4.1. DEVELOPMENT APPLICATION DA0312/2025 - 160-172A BATHURST STREET - CHANGE OF USE TO A MEDICAL CENTRE, PHYSIOTHERAPY CONSULTANCY, AND GYMNASIUM.....	2
 4.1.1. DA0312/2025 - Plans to be endorsed.....	2
 4.1.2. DA0312/2025 - 160-172A Bathurst Street Launceston - TasWater SPAN...	136

164 BATHURST ST LAUNCESTON

Ref No: DA 0312/2025
Date: 29/11/2025
Planning Administration

Figure 51 – Carpark plan showing pedestrian ways shown in diagonal hatching

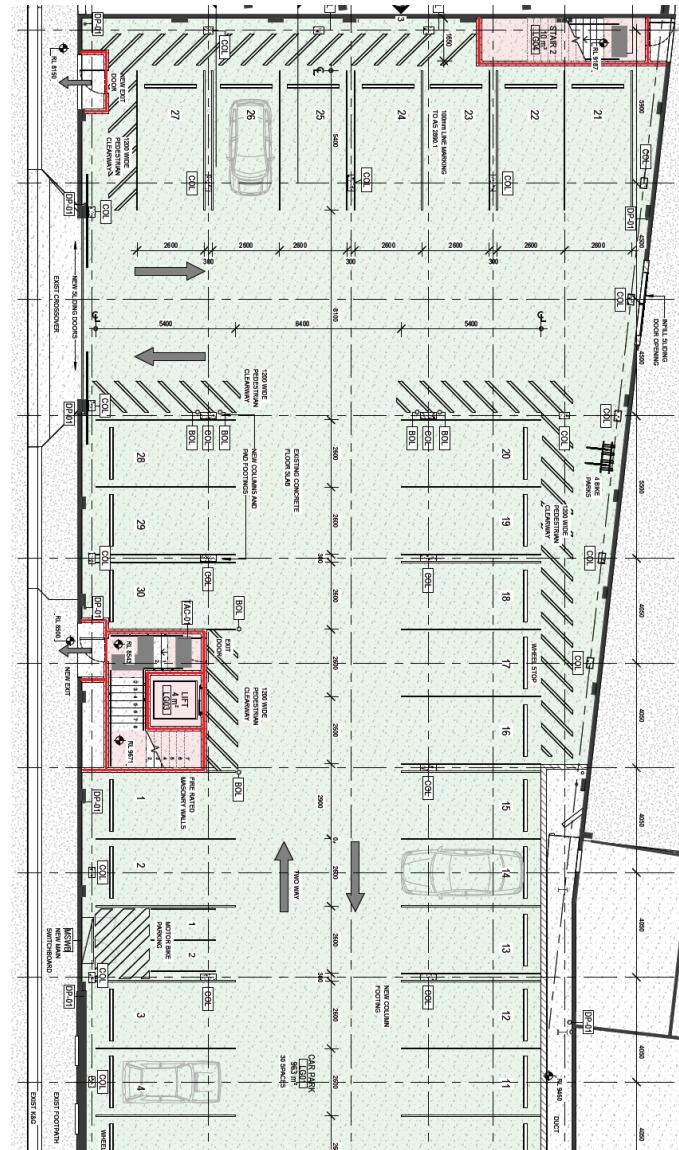
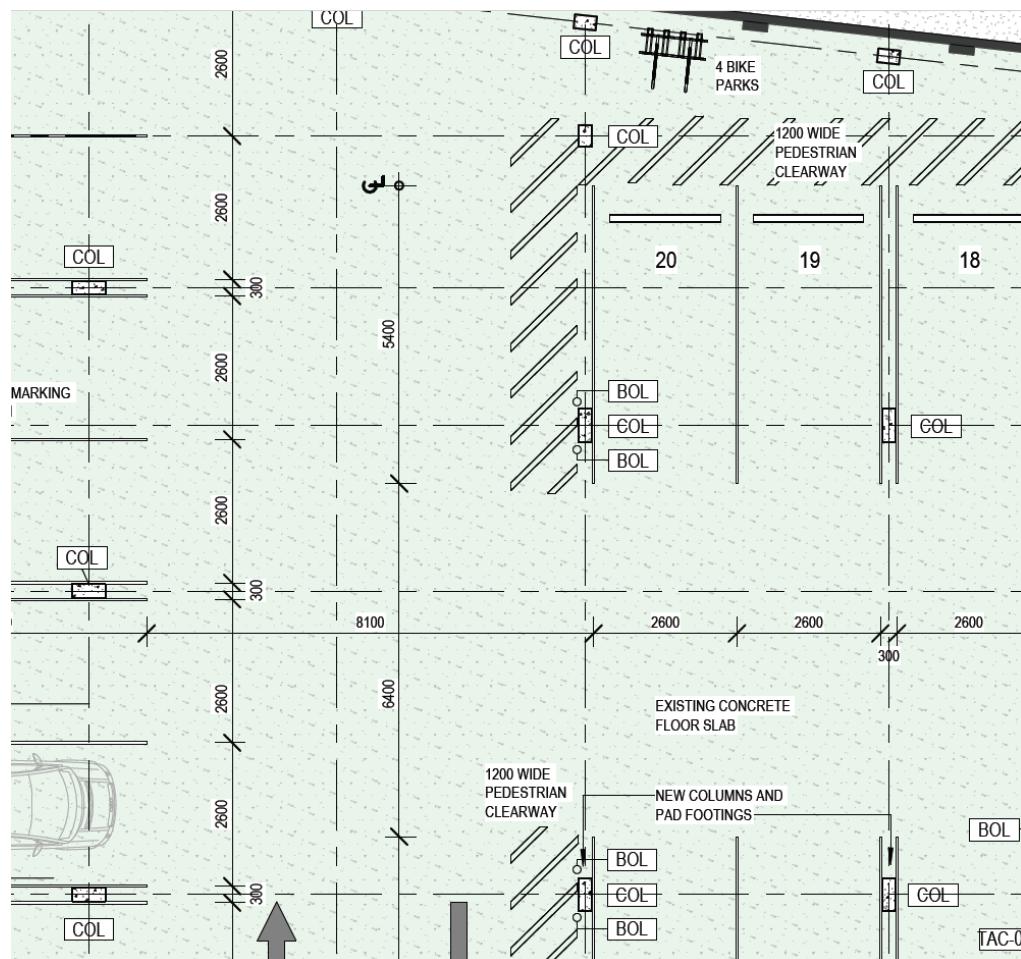
Following review of the use and car parking numbers an updated response may be required to whether safe and convenient pedestrian access is provided to the proposed development in response to C2.6.5 P1.

Refer to enclosed attached Traffic Impact Assessment document (File Name: 164 Bathurst St Final TIA) for response to C2.6.5 Pedestrian Access.

The site has insufficient width to provide footpath and 2.5m separation to the driveway throughout. Figures 51 & 52 show the proposed pedestrian facilities.

As the crash risk is considered low the proposed pedestrian facilities are considered adequate.

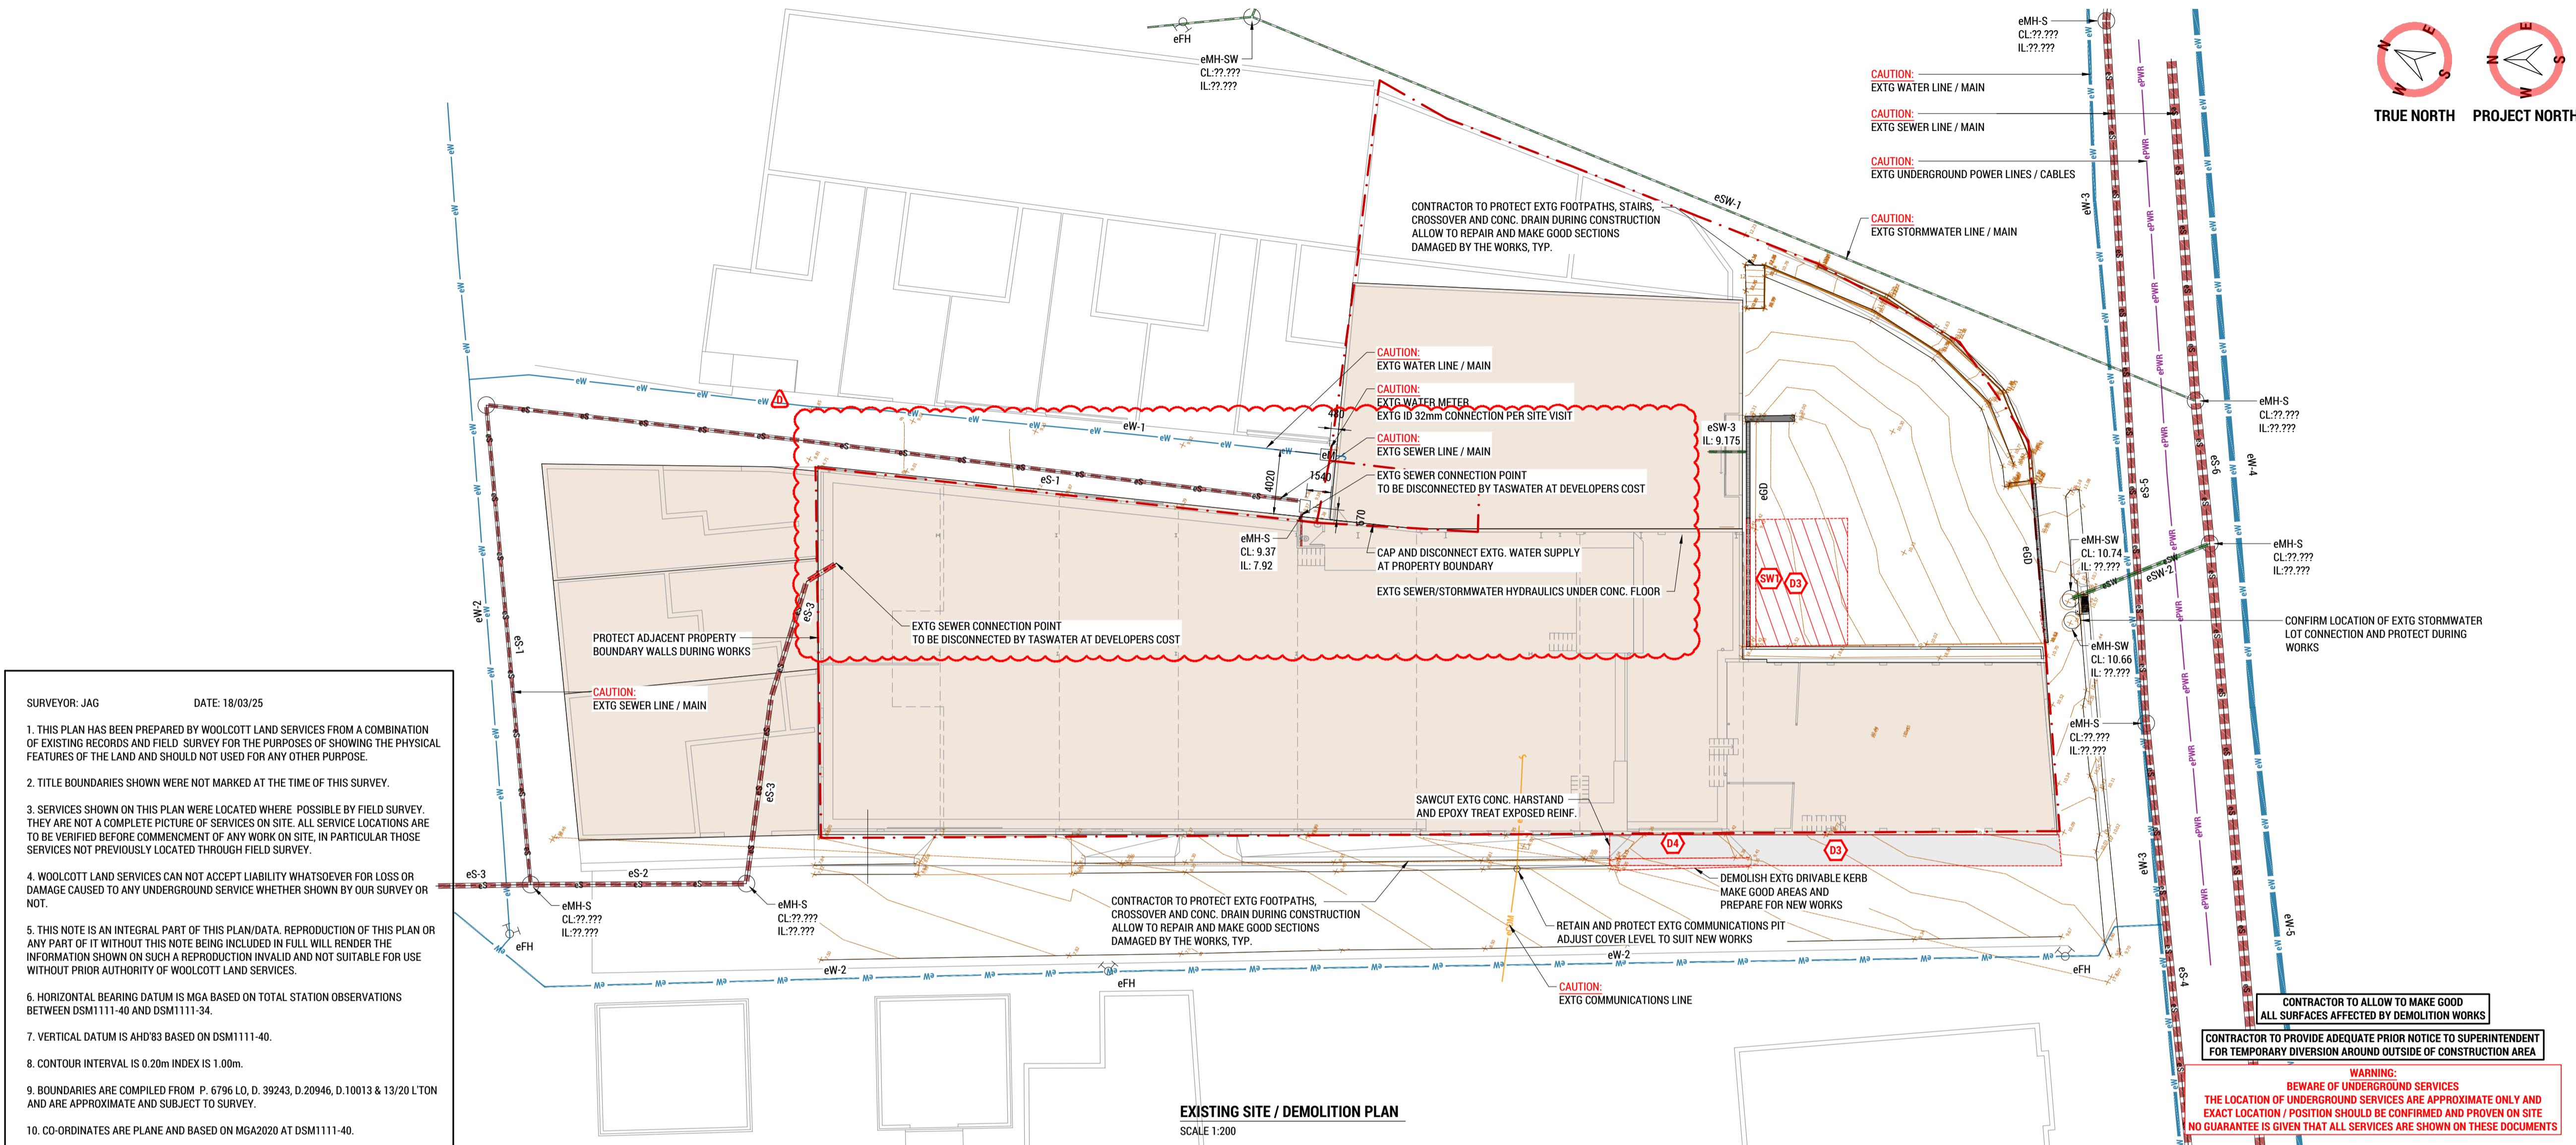
The location of stormwater connections for the car parking area has not been identified. Please update plans to show how stormwater is drained to a public stormwater system in accordance with standard C2.6.1.
